March 11, 2024
Updated August 1, 2024
ES-8332.02

Earth Solutions NW LLC

Subject: Plan Review
2436 – 74th Avenue Southeast
Mercer Island, Washington

ES-8332.02
 74th Avenue S.E. Property
 Parcel B
 Cross Section B-B'
 Existing Geometry
 Seismic Condition
 Horizontal Acceleration = 0.329

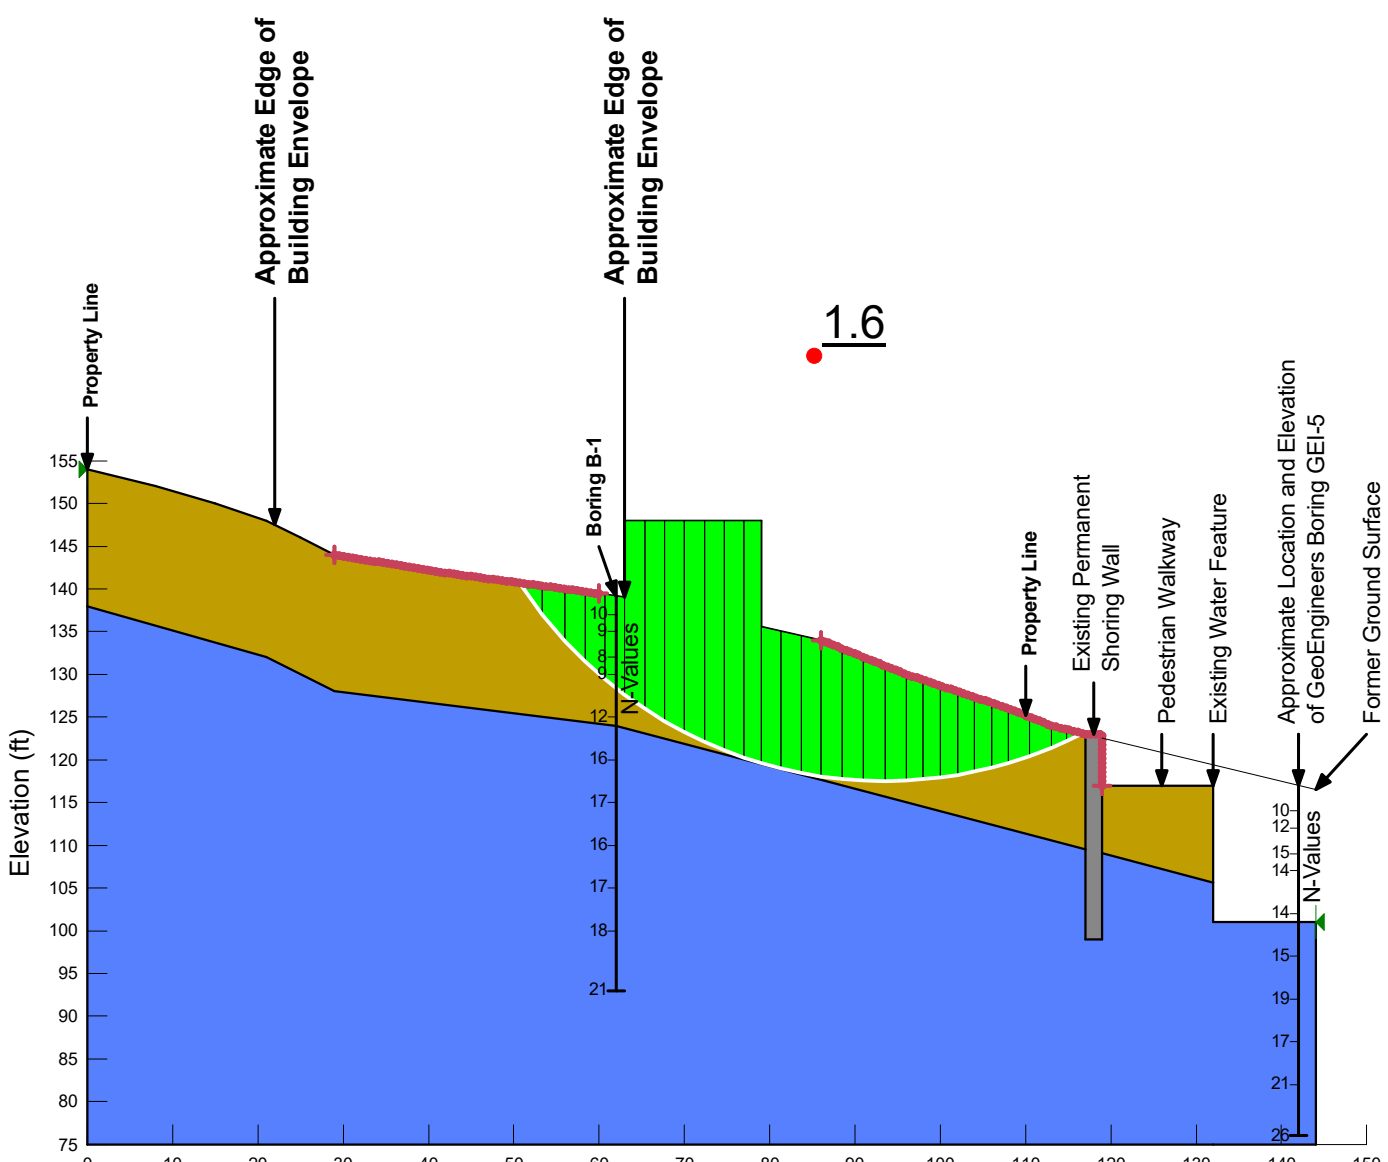
Please have the geotechnical engineer provide stability calculations of the proposed wall and fill slope to verify that the proposed configuration has long term stability under static and seismic loading conditions.

The geotechnical engineering report (page 11) indicated that "fill placement should not occur along sloping areas of this site".

Please revise proposed grading to conform with geotechnical recommendations or have the geotechnical engineer provide specific fill placement recommendations (e.g. recommended dimensions for notching fill into existing sloping ground at this location). Please include detail and/or notes on plan sheet.

We understand the owner has explored the feasibility of placing fill off the east side of the residence to provide safe useable yard area. The original geotechnical report recommended against placing fill on the slope; however, updated slope stability modeling attached, using geofoam backfill, indicates that stability will not be adversely impacted by the proposed grading on the slope.
